The 12510 15th Avenue NE site is located along an active commercial corridor at the intersection of three neighborhoods: Pinehurst, Olympic Hills and Victory Heights. The project team seeks to design a multi-unit development with 5 ground level retail spaces, one live-work unit and 38 townhouse units. The small pedestrian oriented retail will enhance varied existing neighborhood context.

From our Second Recommendation Meeting on March 13, 2017, there were four main Priorities and Recommendations presented by the Board. The Design Team reviewed the pertinent Design Guidelines and reassessed the vision for the project. The following pages are the detailed recommendations and our responses and solutions to these items.

SECOND RECOMMENDATION MEETING - MARCH 13, 2017

AUTO-TURN DIAGRAM

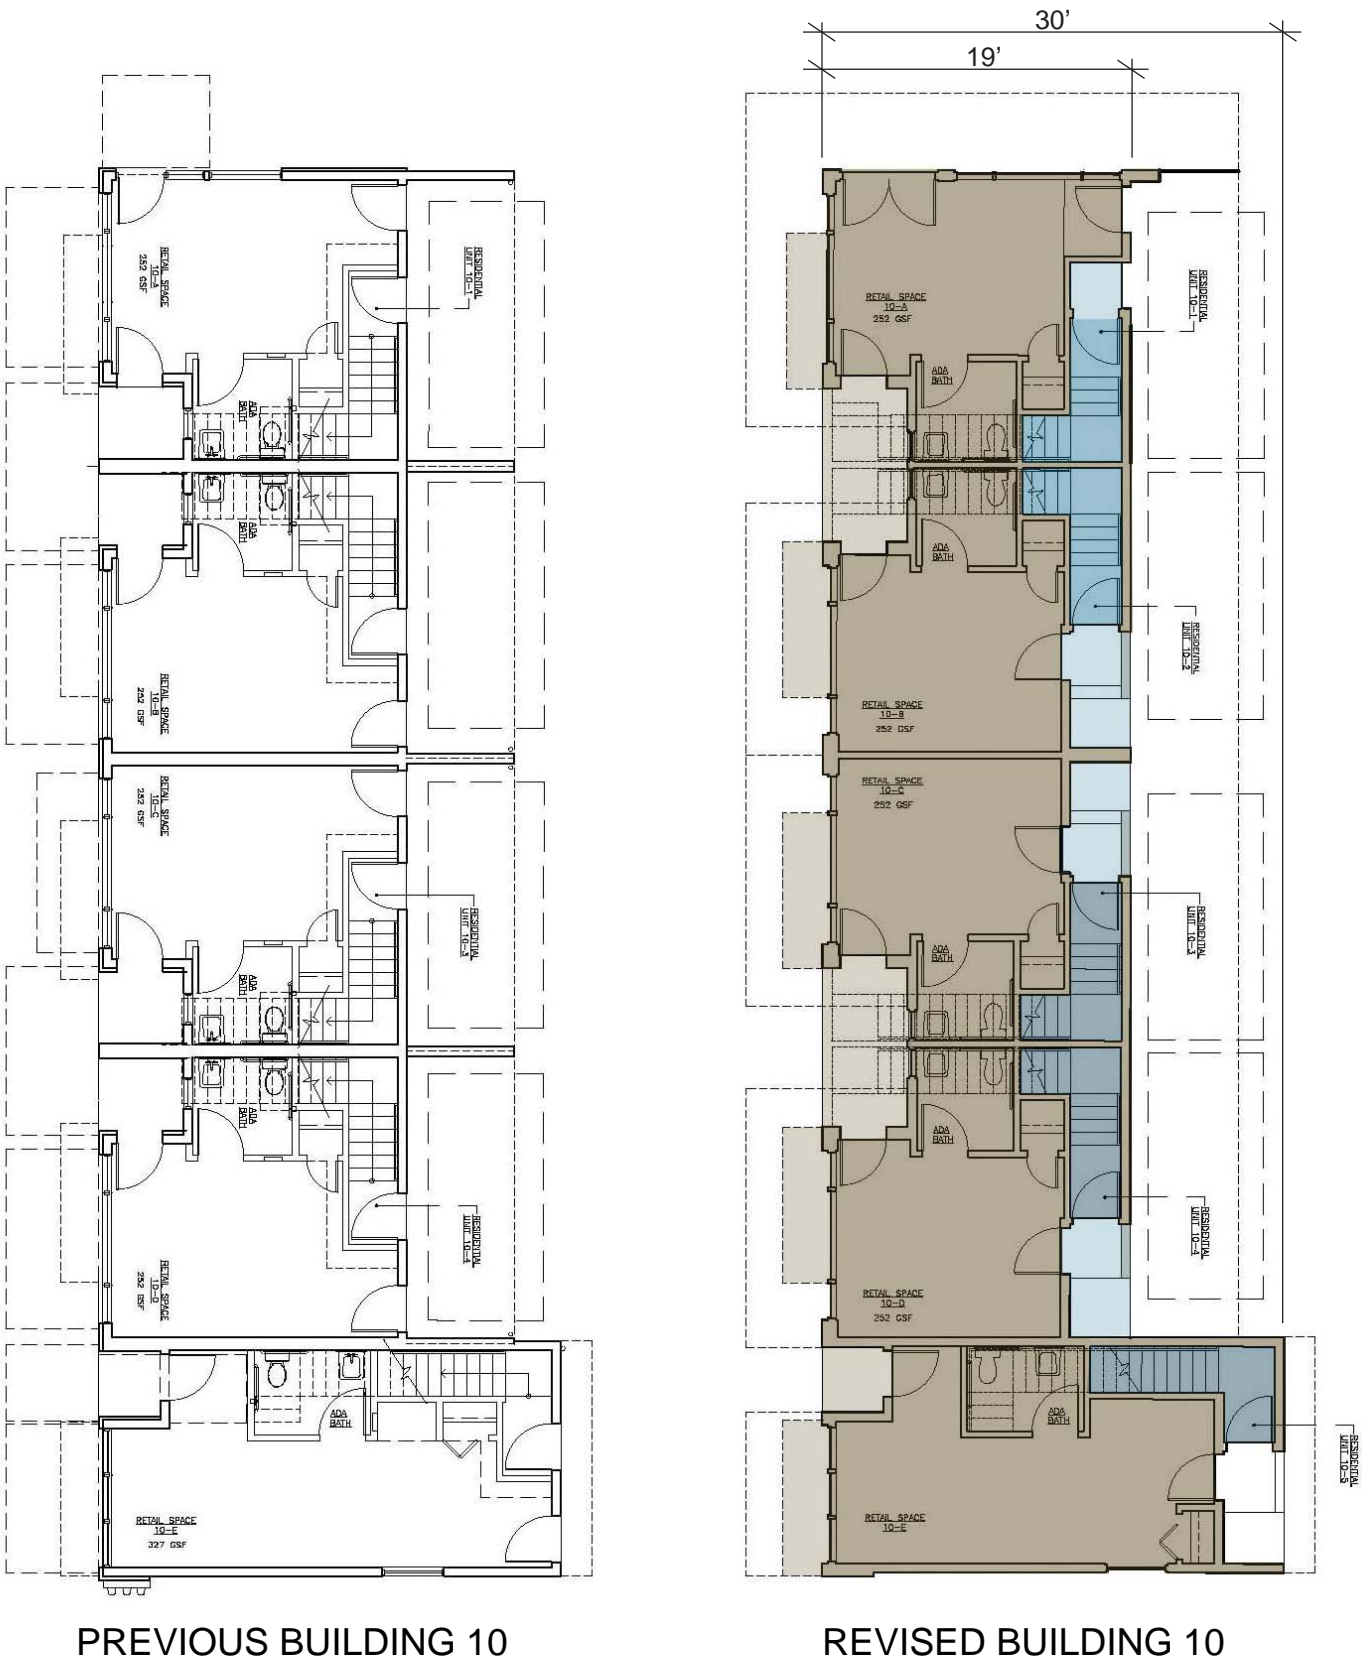
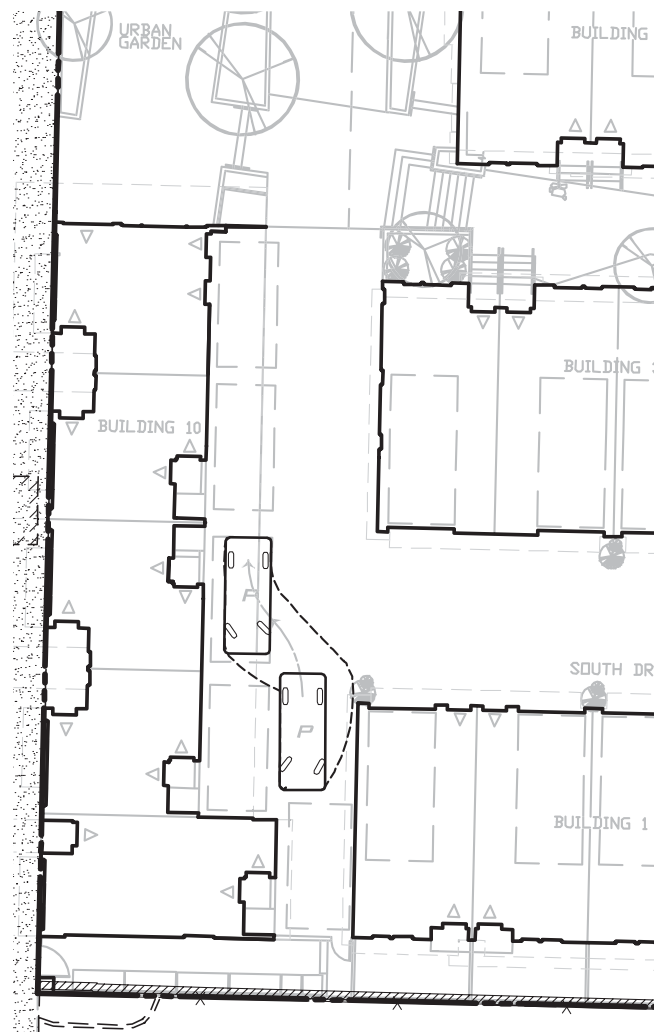
The Code requires that non-residential uses extend an average depth of at least 30-feet and a minimum depth of 15-feet from the street-level street-facing facade. The applicant proposes a reduction to this average depth requirement from 30-feet to 19-feet.

At the second Recommendation meeting, the Board questioned the viability of these micro-commercial spaces along 15th Ave NE, noting the design is overly similar to commercial viability the concerns behind typical live/work units, which are expressly not allowed in pedestrian zones for this reason. At the EDG meeting, this departure was not requested, and the proposed spaces met the 15-foot minimum/30-foot average requirement. At that time, the Board recommended these units be designed to be viable retail spaces. At the first Recommendation meeting, in response to the proposed reduction in average depth, the Board indicated an interest in the request, but it was not clear how the request better met the intent of the Design Guidelines. At the second Recommendation meeting, the Board expressed concern that access to these residential units could be compromised with the adjacent parallel parking stalls (along Building 10). The residential entries are not clear or easily accessible. As a potential solution, the Board suggested one vestibule to mitigate impacts to unit access. This departure requested as designed was not supported.

Response: Vestibules have now been introduced for the unit entries to ease and clearly identify unit access from the parking spaces. Partitions between stalls have been removed to allow better access to vestibules.

AUTO-TURN DIAGRAMS

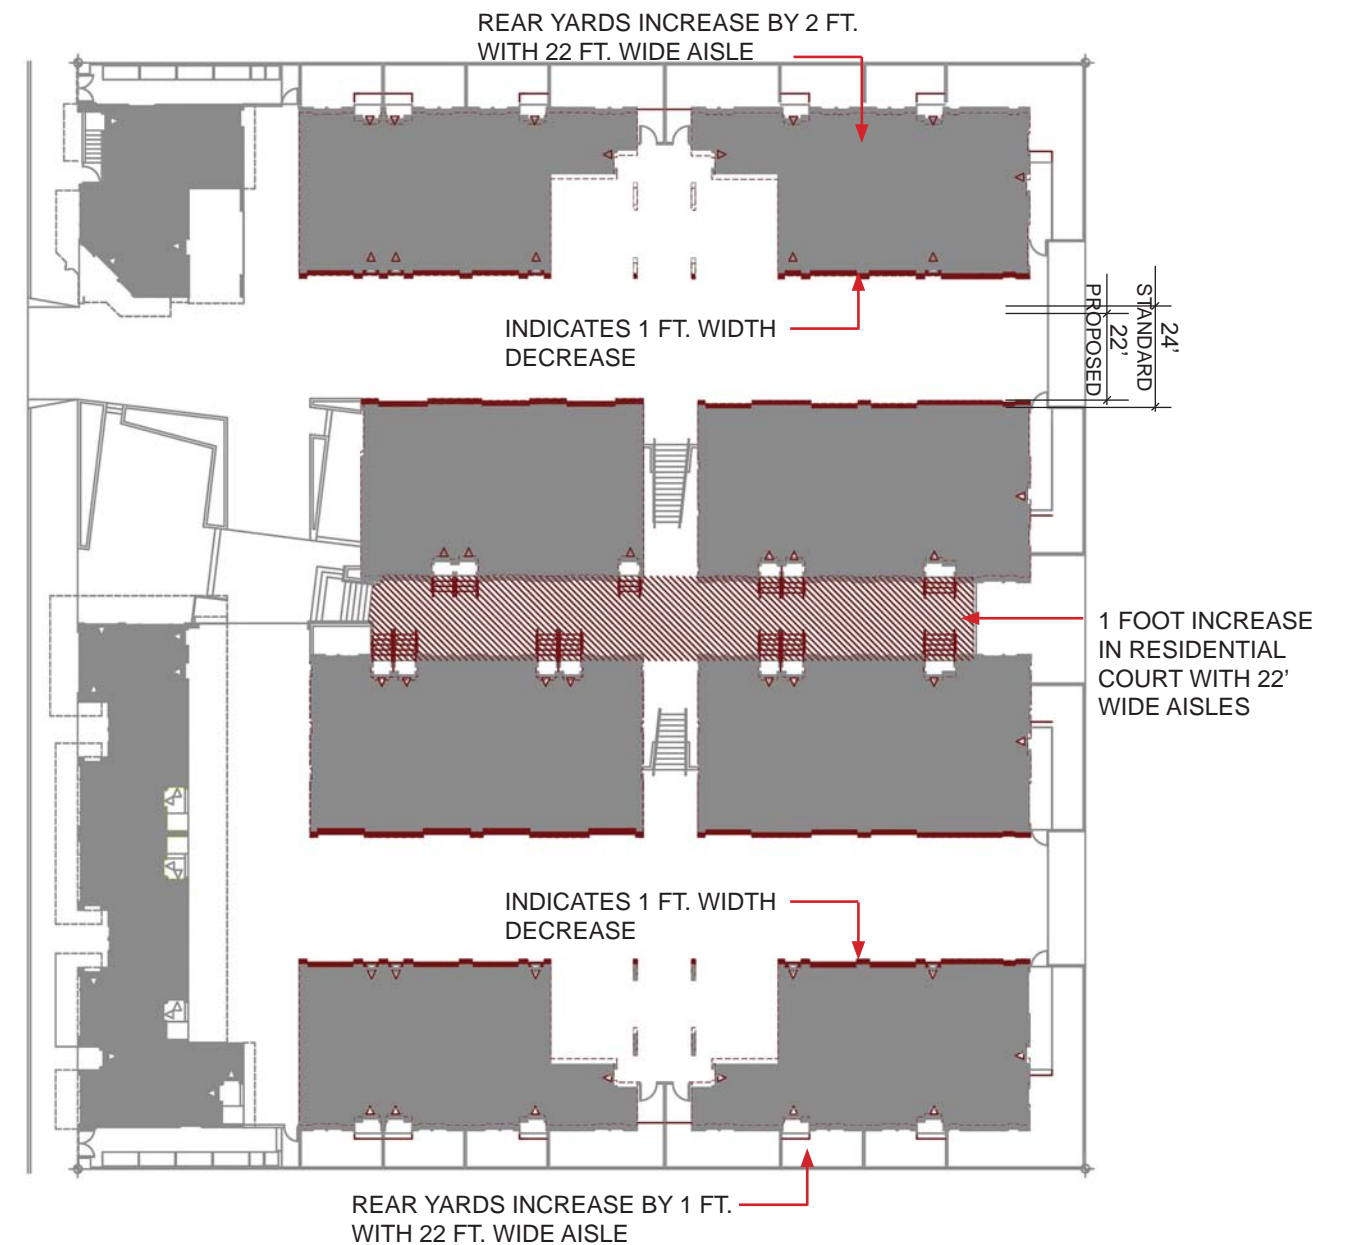
The Code requires that the minimum aisle width shall be provided for the largest vehicle served by the aisle. Large stalls require 24-foot aisle for two-way traffic. The applicant requests a reduction of the aisle width to 22-feet.

The applicant's justification for this reduction in drive aisle width was to allow for additional stalls abutting Building 10 and provide additional landscaping along the perimeter of the site within the setbacks, in conjunction with a vibrant shared open space design. The Board expressed concern that the design provides an insufficient response to guidance provided at the previous meetings, at which time the Board recommended large, usable, activated, shared open spaces. At the second Recommendation meeting, the Board noted that the north and south setbacks could be reduced to allow for a greater amount of area within the urban garden to ensure a successful shared open space. The Board requested diagrams illustrating how vehicles will maneuver into/out of the parking stalls adjacent Building 10. This departure requested as designed was not supported.

Response: As initially stated in the EDG of June 8, 2015, the board supported the 2 ft. decrease of the drive aisles to support the creation of more open spaces, in particular that of the central courtyard and the tenant side yards. This is still the people over cars design intent and overall theme of the Pinehurst project. Auto-turn diagrams have been included as requested.

AUTO-TURN DIAGRAM

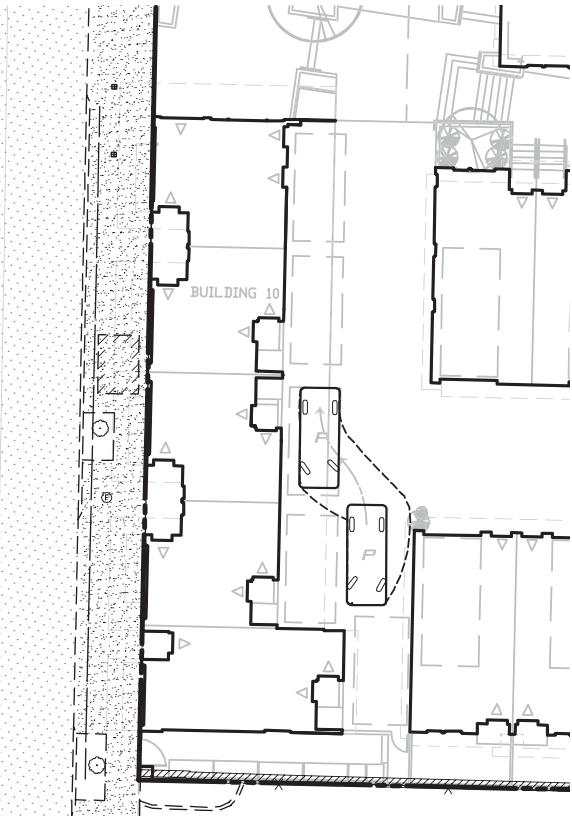
The Code requires that the minimum aisle width shall be provided for the largest vehicle served by the aisle. Large stalls require 12-feet for zero-degree parking for one-way, and 20-feet for two-way. The applicant proposes a reduction to 14-feet for a two-way aisle.

The applicant's justification for this reduction in drive aisle width was to allow for additional vehicular parking stalls abutting the east side of Building 10. The Board expressed concern that the reduced widths and parking as proposed would result in difficulty for vehicles maneuvering through the site, and that the drive aisles were not designed as was recommended at both the EDG and the first Recommendation meeting. At the previous meetings, the Board recommended the drive aisles be treated as shared streets that would accommodate both vehicles and pedestrians, functioning as shared open space rather than voids within the site. At previous meetings, as well as the second Recommendation meeting, the Board recommend additional landscaping and green features be incorporated into the design of these spaces. The Board requested diagrams illustrating how vehicles will maneuver through the site, and particularly into/out of the parking stalls adjacent Building 10. This departure requested as designed was not supported. (DC1-B, DC1-C)

Response: The structure and partitions (A) between these parking spaces have been removed to ease parking. An auto-turn diagram has been provided.

REDUCED SETBACK ALLOWS PROJECT TO TRANSITION INTO SINGLE-FAMILY BULK AND SCALE, RESPECTING CONTEXT OF ADJACENT SITES

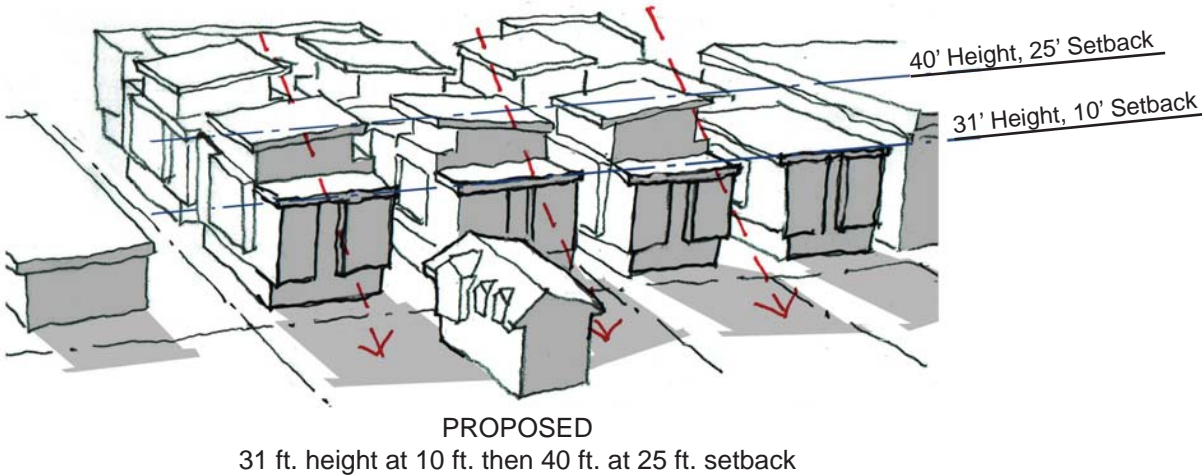
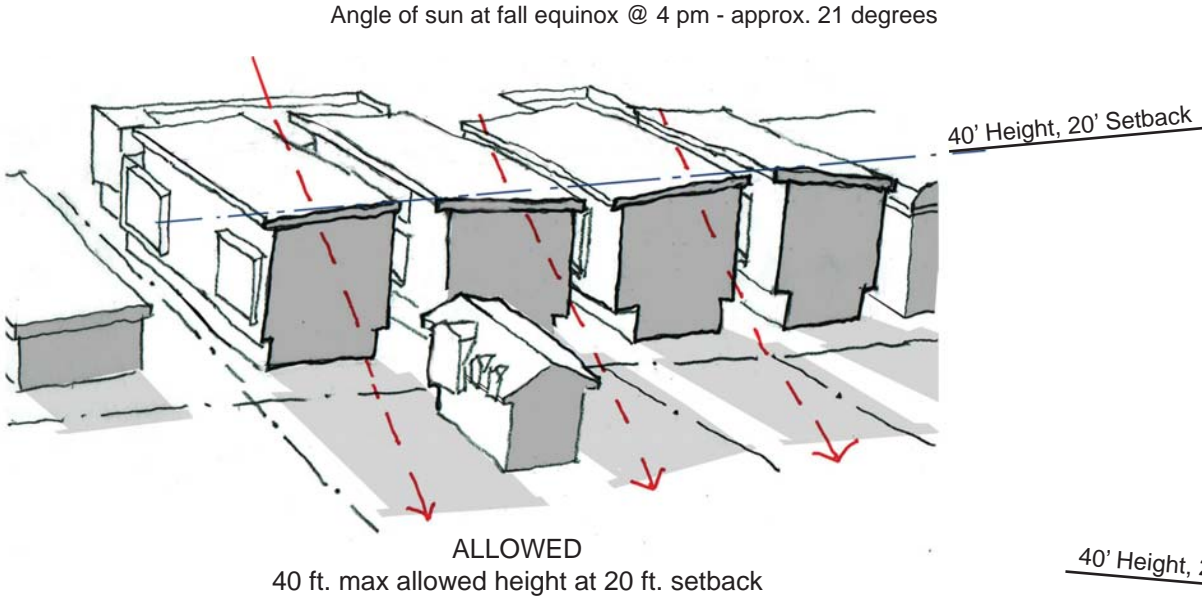
The Code requires a rear setback of 20-feet for multifamily structures, or the minimum required by the standards of the underlying zone for multifamily structures, whichever is greater. The applicant proposes a reduced setback of 10-feet.

At the second Recommendation meeting, the Board discussed the magnitude of the departure request: a 50% reduction in required setback from 20-feet to 10-feet. The Board did not feel that this departure request better met the intent of the Design Guidelines, and that unit count and internal functionality appear to be self-imposed hardships that are not providing a successful resolution to the site design. The Board noted concerns regarding privacy, zone transitions, and availability of light and air to the adjacent single-family development to the west. The Board did not support the 50% reduction request. (CS1-B, CS2-D, CS2-III)

Response: By allowing units closer to the rear setback, we can provide a separation of the units closer to the center of the site. This will allow for a smaller massing and more glazing for the end units. On the upper level, our units will setback an additional 15' and will have less solar impact than the code allowed height.
